Havant Thicket Reservoir - Phase 9 Planning Application - APP/26/00574

Visitor Centre, Bird Hide, Hub Building & NW layout Reserved Matters

I **object** to application APP/26/00574 for the Visitor Centre, Bird Hide, Hub Building and North-west layout of the reservoir site for the following reasons;

Specific concerns about the current hide design;

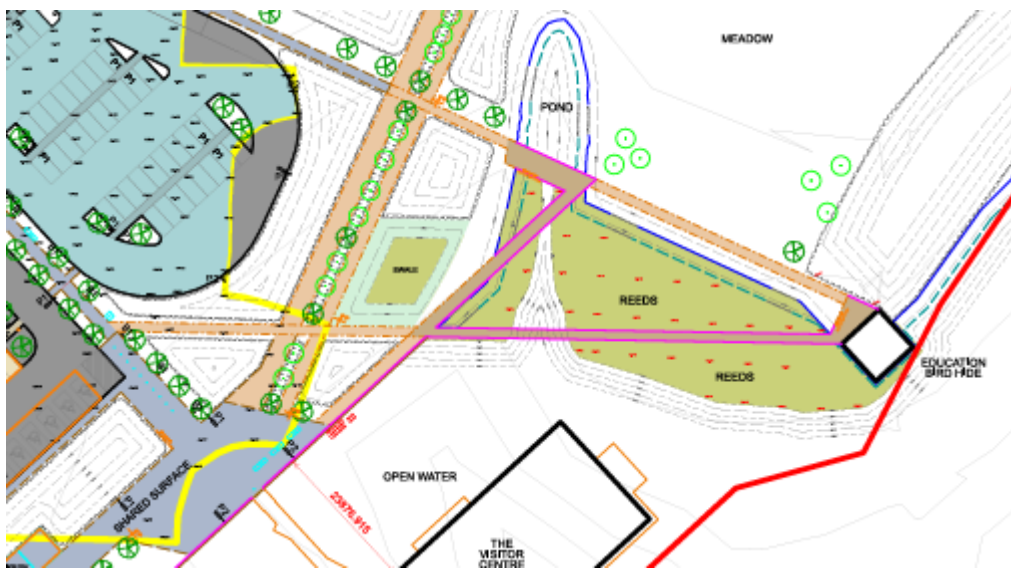
- a) The hide is too small (7.7m x 7.7m) creating a wasted opportunity to provide a more useful facility, the parameters from the original reservoir planning application allowed for a much larger building envelope of 9m x 20m (*Planning Statement page 23*).
- b) A larger longer structure orientated along the shore of the wetland in a v-shaped frontage would provide more capacity and greater viewing opportunities over the wetland.

- If the NE and SE frontages were pivoted more to be angled to the water frontage (v-shaped) the hide would provide better viewing opportunities over the wetland, especially in different light conditions.

- c) The hide is only designed for a half class of 15 pupils; there is no indication that it has been designed to be dual use (multi use) and its layout is not optimised for that. A longer hide would open up the opportunity for more seating, a second access door, and provision of a folding screen to separate off the education area for a half class when needed, as is provided at Blashford Lakes. The photos in Appendix B of the hide at Blashford Lakes show the different design/ space provided at each end of the hide to allow a multi-function dual use.

Left – Extract of HTR Landscape Masterplan shows no barrier/ hedge along the wetland shore

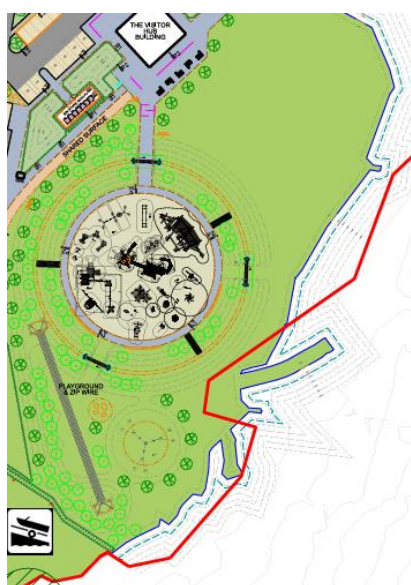
The Landscape Visualisation illustration on Page 7 and 19 of the Landscape Design and Access Statement appears to show railings along part of the water's edge near to the play area (see extract below), but there is no secure barrier (e.g. hedge with

stockmesh fence inside) that would stop children or dogs accessing the shore of the wetland conservation area. This is needed for health and safety reasons near the play area, to prevent disturbance of wildlife using wetland compartment 4, and to prevent people/dogs getting to the wetland retaining structure islands which are only a short distance offshore. Noting that the spillways that separate the islands on the retaining structure that would normally help to discourage access to the islands will be dry during reservoir drawdown, so a robust barrier is essential to prohibit access to the retaining structure islands. The railings shown on the illustration below are not a robust barrier to deter access, but not even these inadequate railings are marked on the general arrangement drawings or Landscape Masterplan (see extract below), no barrier is shown along the wetland shoreline.

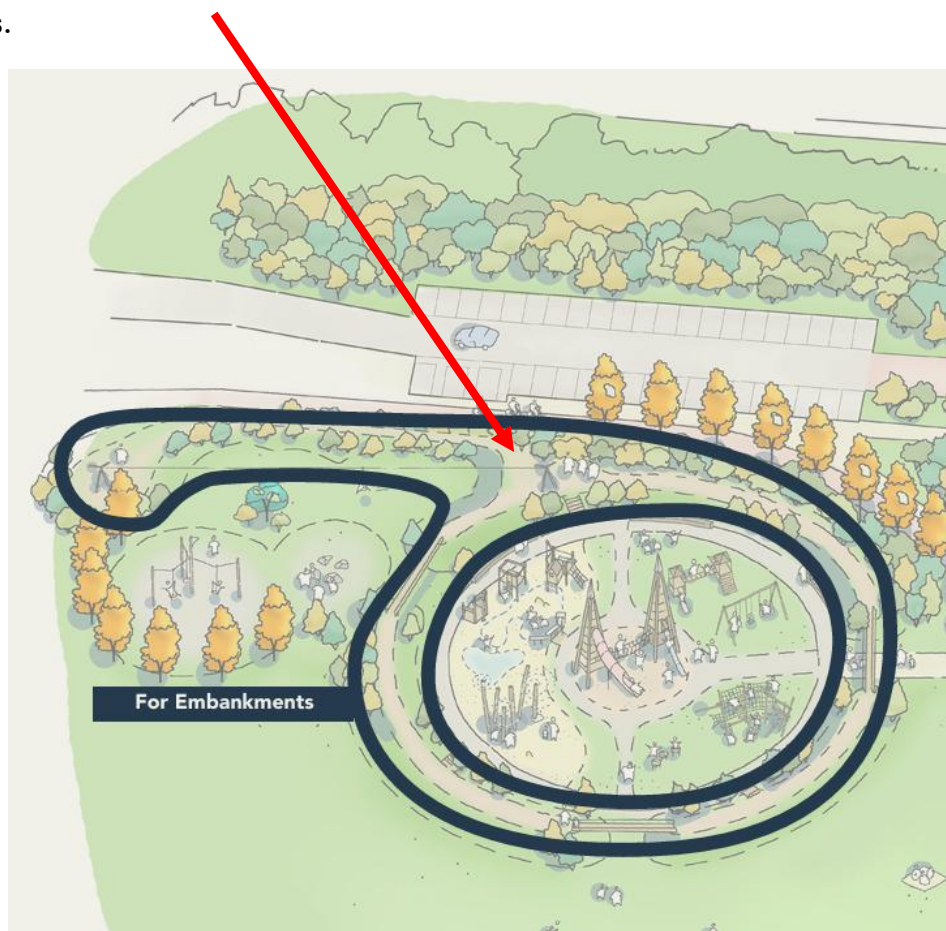
5.3 The artificial channel with the reedbed and pond dipping area NW of the Visitor Centre has no natural source of water and will dry out as reservoir levels drop. If the pond dipping platform is required for use all year round, then when reservoir water levels drop an alternative means of filling this area with water will be needed. No information is provided on how water levels will be retained in the channel.

5.4 No access path to the play area where there will be an obvious desire line; The page 27 extract provided below from the Landscape Design and Access Statement shows a path to play area from southern access path which is not shown on the main drawings.

Summary of the impact of alternative siting of the Visitor Centre as an island or in a shoreline location, including an assessment of the anticipated Disturbance Zones

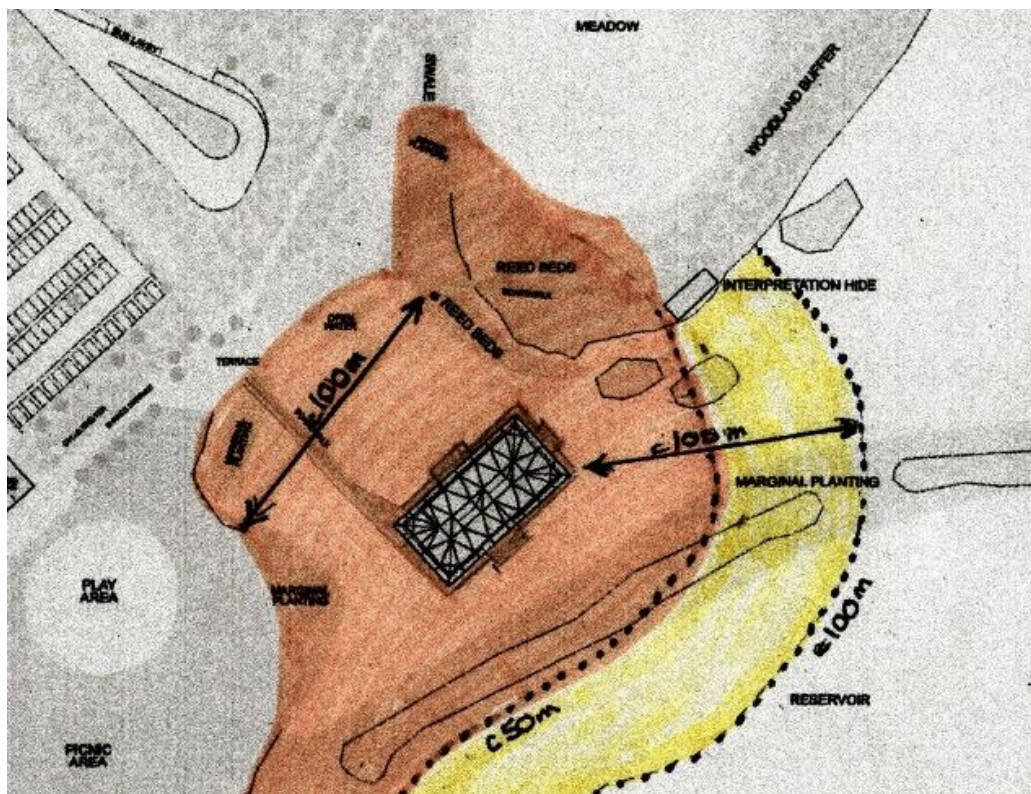
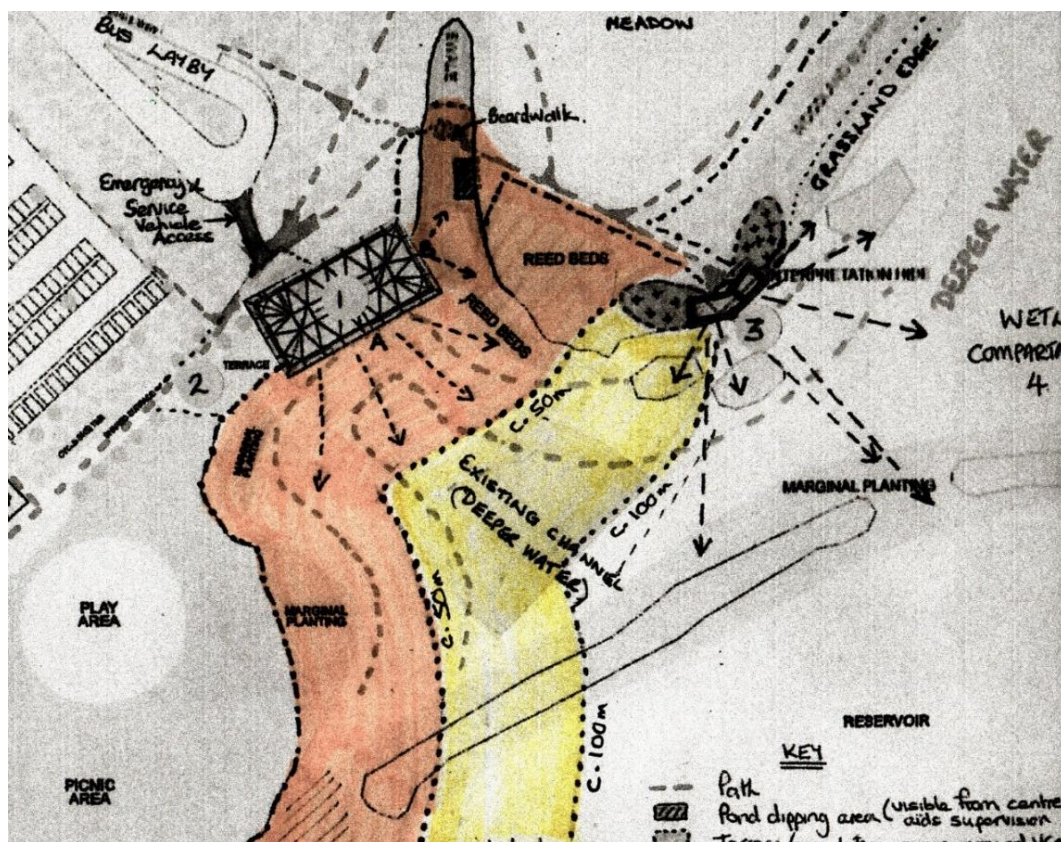
ensures the wetland habitat is disturbed so species available to view would be extremely limited (wasted opportunity)	a great 'wow' visitor experience. Space at rear taken up by toilet, kitchen & offices so does NOT need great views.
Long boardwalk (c.25m) over water for access to the visitor centre maximises disturbance to the wetland as noise of people & silhouettes breaking the skyline is guaranteed to scare off wildlife. Noise of trolley wheels carrying supplies & wheelchairs over boards (hit & miss noise) will add to the disturbance.	Excellent screened access from carpark minimises disturbance from visitors arriving, providing simple ALL ability short access to VC. Great connectivity between VC & terrace. Trolleys carrying supplies enter from rear causing no disturbance to wetland.
VC sits on top of existing valley which would have flooded to provide deeper water habitat.	Existing valley feature (see contours on map above) when flooded will provide a variety of submerged vegetation and deeper water which diving species such as tufted duck and great crested grebe could use & still be visible from the shore & VC.

Limited opportunity for intelligent design of the building to reduce disturbance as visitors, including children and dogs will be present causing disturbance outside the structure.	Intelligent design in location and layout can minimise impact on wetland. For example, sealed windows on south & east facades, vents can be directed away from wetland, building can help screen noise from the terrace, fencing & low hedging along shore can facilitate great views but stop dogs/ children disturbing the wetland shore.
Very exposed location of VC/ café and SW prevailing wind will make it impossible to stop litter blowing into the wetland (paper cups, napkins, drinks cans, wrappings & stirrers)	VC location sheltered by trees/ landscaping reducing the wind and risk of litter being blown into the wetland. Litter blown off tables can be captured on fence/low hedge around terrace on shore.

Map 1 - Island Location - Visitor Centre as an island

Map 2 - Shoreline Location - alternative siting would reduce disturbance of wildlife and impact on the wetland (located within permitted VC area box in outline hybrid permission)

Inadequate allocation of space for Grounds Maintenance Storage & Workshop in 2026 planning application

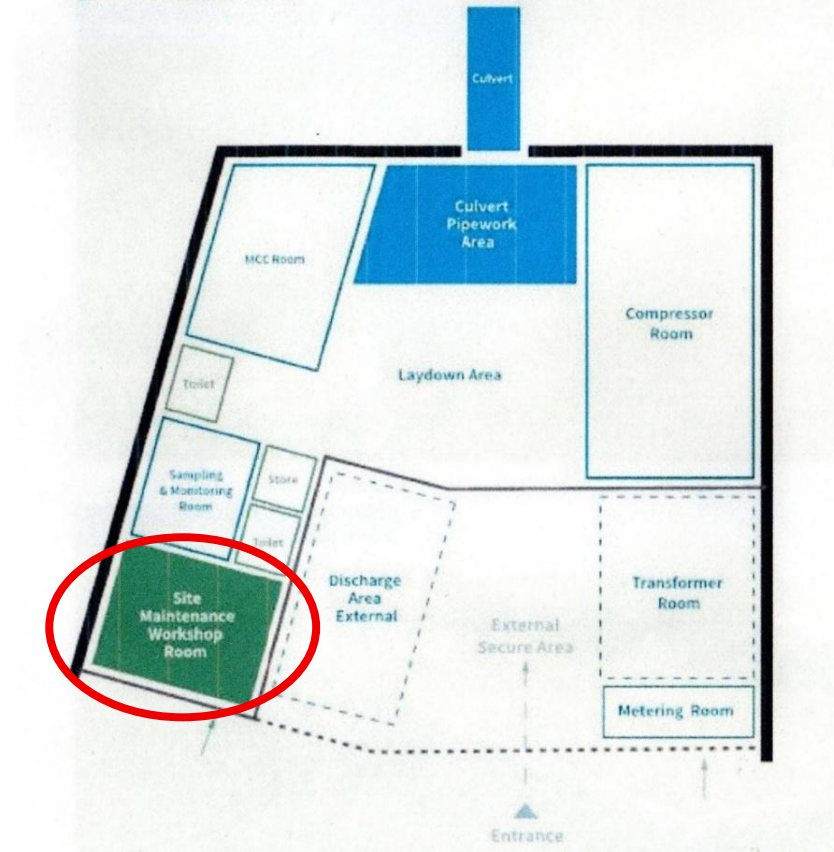
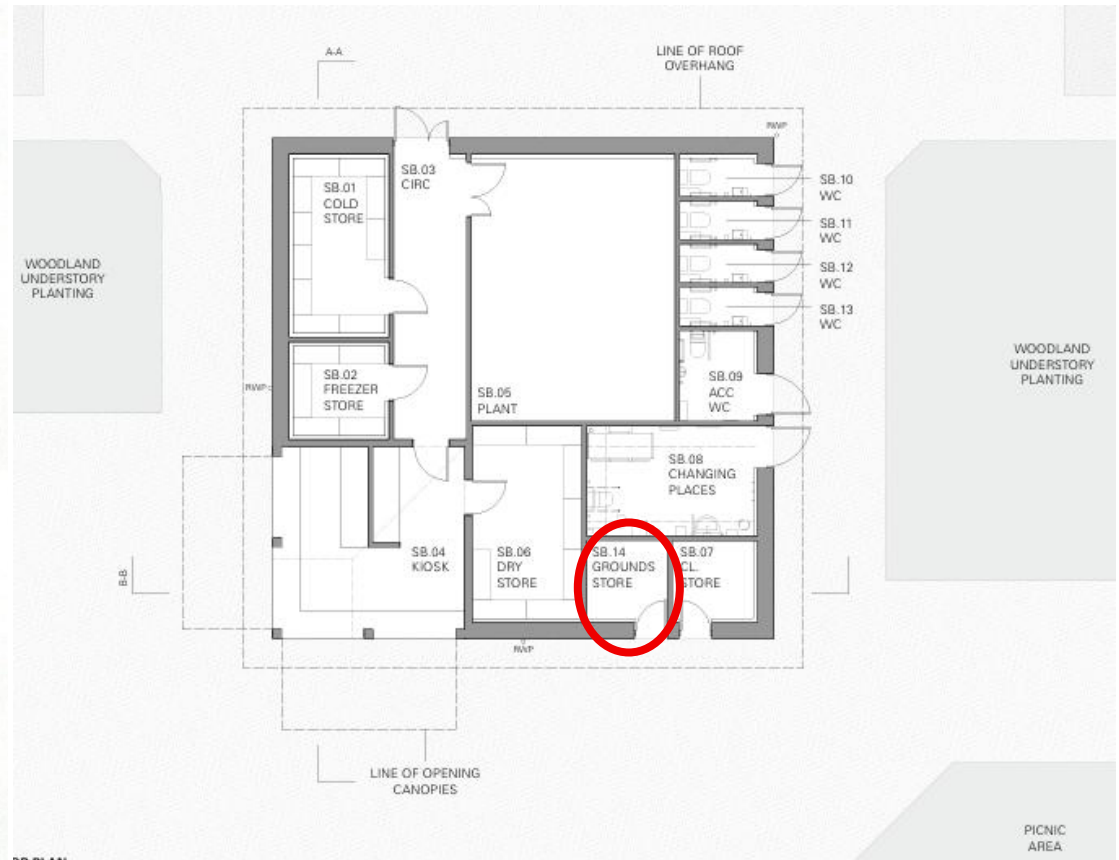
includes only a very small Grounds Store (no workshop space)

The 'Grounds Store' shown within the 2026 Visitor Centre Hub building should have been designed to replace the Grounds Maintenance Store & Workshop area removed from the Control House building layout but it is much smaller and not fit for purpose.

There will not be space in the Visitor Hub plant room as this is to be used as an energy centre and plant room serving the needs of the Visitor Centre and Hub Building.

If the LPA is minded to approve the current application for the NW corner of the reservoir, then a planning condition should be applied requiring provision of a larger Grounds Maintenance Store & Workshop at least equivalent in area to that originally shown in the hybrid outline application/ permission within the Control House building, with the layout ensuring direct vehicle access.
